CX Posting No.: DOE-ID-INL-22-009 R1

SECTION A. Project Title: TAN Utility Corridor R1

Revision 1.

Figure R1

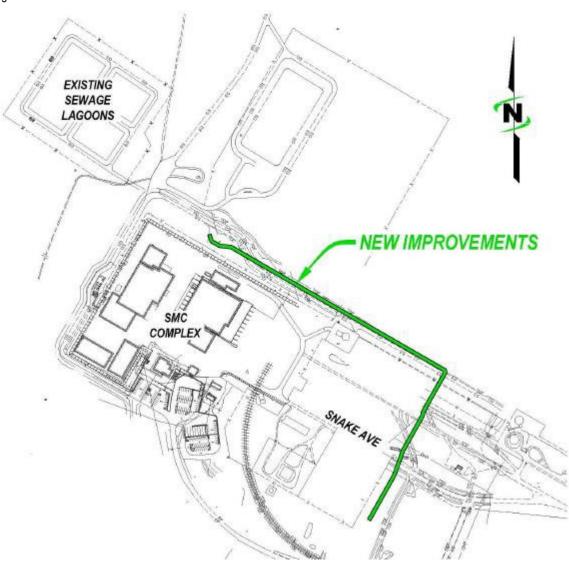
The purpose of this revision is to address a design change in the TAN Utility Corridor regarding the sewer system. The project will no longer be installing a septic system and will instead install a sewer line connecting to the existing sewage lagoons located north of SMC. See Figure R1 for proposed alignment of the gravity and pressure sewer mains. The alignment begins with a new gravity sewer main located north of Nile Avenue and southeast of the SMC Complex. This main runs to the north to the new sanitary sewer lift station, located north of Snake Avenue. From this point, a new pressure main runs to the north for approximately 500 feet and then turns to the west until it connects into the existing sanitary sewer lift station, located northeast of the SMC Complex. As shown in Figure R1, Figure R2, and Figure R3, the sanitary sewer new lift station will be located at the downstream end of the new sanitary sewer gravity mains, which is directly north of Snake Avenue, southeast of the SMC Complex. The lift station will receive wastewater from the new 8-inch gravity sewer main and discharge it through a single 4-inch pressure main that will connect to the existing sanitary sewer lift station, eventually conveying the wastewater to the SMC STP. The lift station will consist of a wet-well mounted pumping station with duplex, submersible, non-clog pumps enclosed in a concrete wet-well structure. The pumps will alternate on pumping cycles to provide even wear. Each pump will be capable of handling the ordinary peak flows, which will provide redundancy and allow maintenance of one pump and still leave the lift station in service. A high-level float switch will turn on both pumps to provide for extra large peak flows which may occur at extremely infrequent intervals. The pumps will be grinder pumps which will grind the sewage into a slurry and pump to a new pressurized sewer main. A back-up portable diesel generator and automatic transfer switch will be available near the lift station to provide auxiliary power in the event of an outage. The electrical and control panels will be located on a free-standing equipment rack near the lift station. Alarm outputs will be included in the control panel and will include power failure, pump failure, high water level, and low water level alarms. Each of these alarm signals will be sent to a local alarm and light at the lift station to inform the maintenance staff of the status of the lift station. Since the new lift station and new collection system will be capable of serving a much larger service area than what will be originally required and due to the small flows, the wastewater will be stored in the lift station wet well for extended periods of time until the wastewater level rises high enough to start a pump. This extended storage time in the lift station may result in odor issues as well as other maintenance issues. For these reasons, carbon filters on the wet well vents will be installed to mitigate odor problems. During initial operation with extremely low flows, the pump ON/OFF level set-points should be tightened as much as possible to minimize the operating volumes and cycle times. However, a minimum operating volume should be maintained to provide reliable level control and avoid cycling of the pumps in excess of the manufacturer's recommendations (typically less than 8 to 10 starts per hour). Also, it may be necessary to supplement the wastewater flow with additional clean water to keep the pumps cycling more often (e.g. 2-3 times per day) since the initial flows will be lower than designed for. Any infrastructure to add clean water will need to comply with cross-connection control regulations with approved backflow prevention measures. Other utilities including water, telecom and power as described in the original scope will be unchanged.
